E4435B-10**S E R V I C E N O T E**Supersedes:
NONE**ESG “B” Signal Generator E4435B**

Defective Waveform Sequence SRAM on the Dual Arbitrary, UND board (A5) and iDEN Dual Arbitrary, Special Option H60 board causes waveform become distorted when playback.**To Be Performed By: Agilent-Qualified Personnel****Parts Required:**

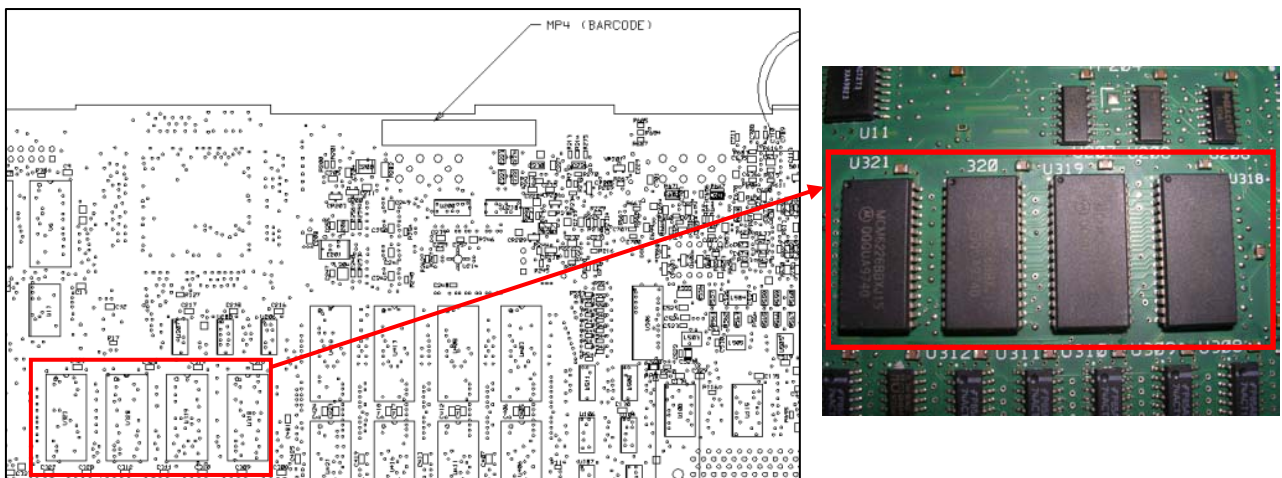
1. Repair on failure.
2. Prevent future occurrences due to a defective waveform sequence memory chips (U318, U319, U320, U321) by replacing the 4 affected chips.
3. Locate the U318, U319, U320 and U321 which are located at the bottom side of the UND or H60 board.

4. Replaced the affected components. **Caution:** Please use the appropriate soldering tools and you must be certified to perform the soldering to prevent any quality or reliability issue due to soldering workmanship.
5. Once the affected components had been replaced, perform:-
 - i) Dual Arb Waveform Generator Check. This test can be performed by using the TME software or the ESG-B Classics Software, and
 - ii) If customer waveform is stored in the NVARB RAM, playback the waveform and observed on the oscilloscope for any waveform distortion.
